Arthurs Seat Road
Road Safety Assessment

Document type	Existing Conditions
Project title	Arthurs Seat Road Road Safety Assessment
Report number	S20240449

Safe System Solutions Pty Ltd has been engaged by Mornington Peninsula Shire Council to undertake an independent assessment of the Arthurs Seat Road Black Spot project between White Hill Road and Red Hill Road.

Figure 2 Crash data map

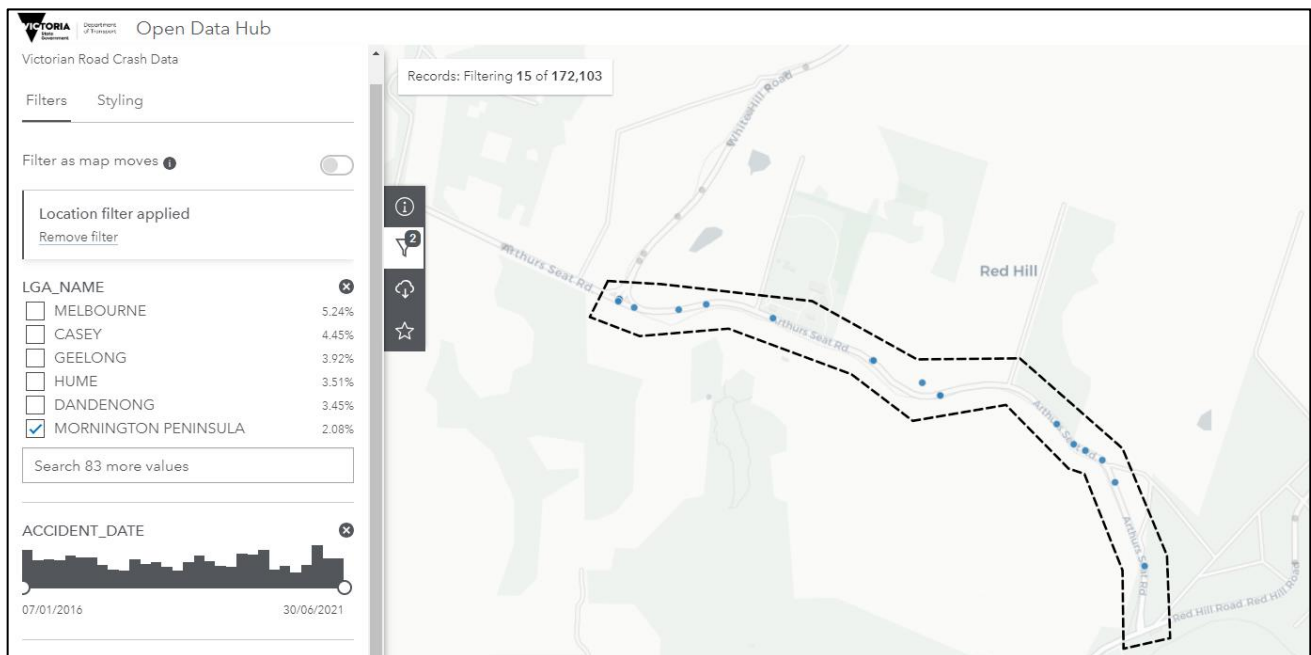
The authors of this document have conducted their own, independent crash query via the publicly available dataset (<https://discover.data.vic.gov.au/dataset/victoria-road-crash-data>). We have filtered crash data on Arthurs Seat Road between White Hill Road and Red Hill Road and found a total of 15 crashes, shown in Figure 2. A table excerpt of this data has also been provided in Figure 3.

- 4 of the crashes that have occurred in this section were run-off-road (loss of control) crash types.
- 6 of the crashes that have occurred in this section were at the intersection Arthurs Seat Road and White Hill Road.
 - 5 of these crashes have **not** been used / referenced as part of the Black Spot SAR. They were all intersection crash types.
 - The 1 crash that was used /reference as part of the Black Spot SAR was a head-on, serious crash

Figure 7 Before and after upgrade AusRAP Star Rating (Four scenarios)

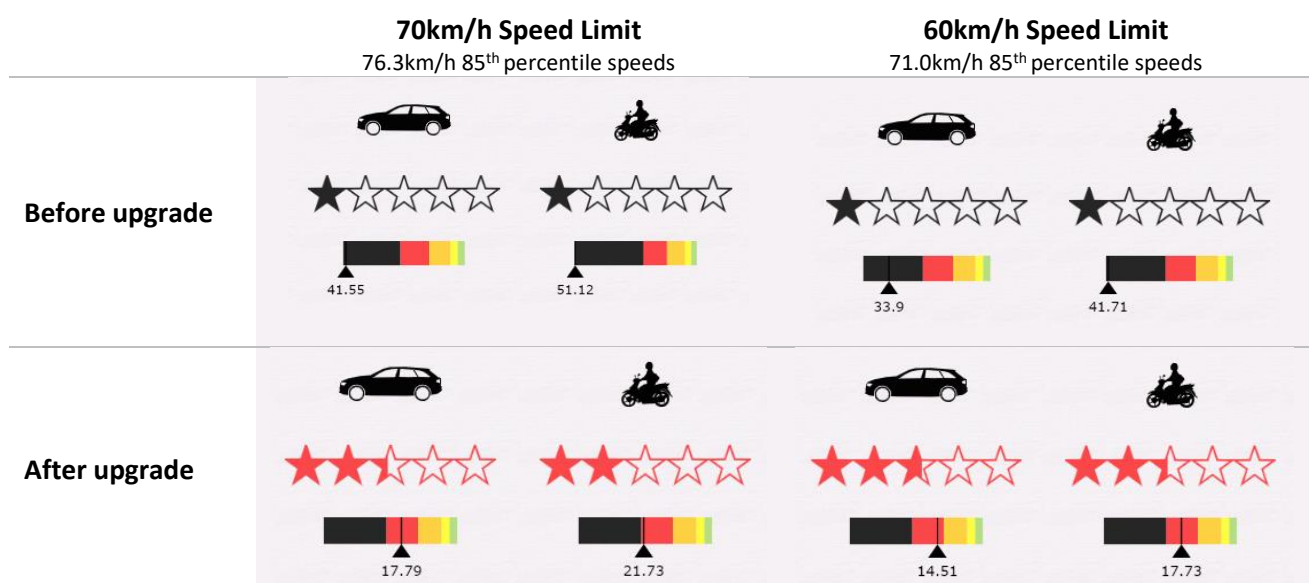
The AusRAP assessment was not completed for each 100 m segment of Arthurs Seat Road but was rather a representative AusRAP assessment. Coding of road attributes was completed based on a representative cross section of the 'before upgrade' determined from supplied photographs, data and historical information available. The 'upgraded' was based on site inspection information at sites with the installation of the barrier systems. For completeness, four scenarios were assessed as represented below.

Each increase in star rating approximately halves the risk of death and serious injury. Thus, the improvements created in these sections of Arthurs Seat Road are considerable.
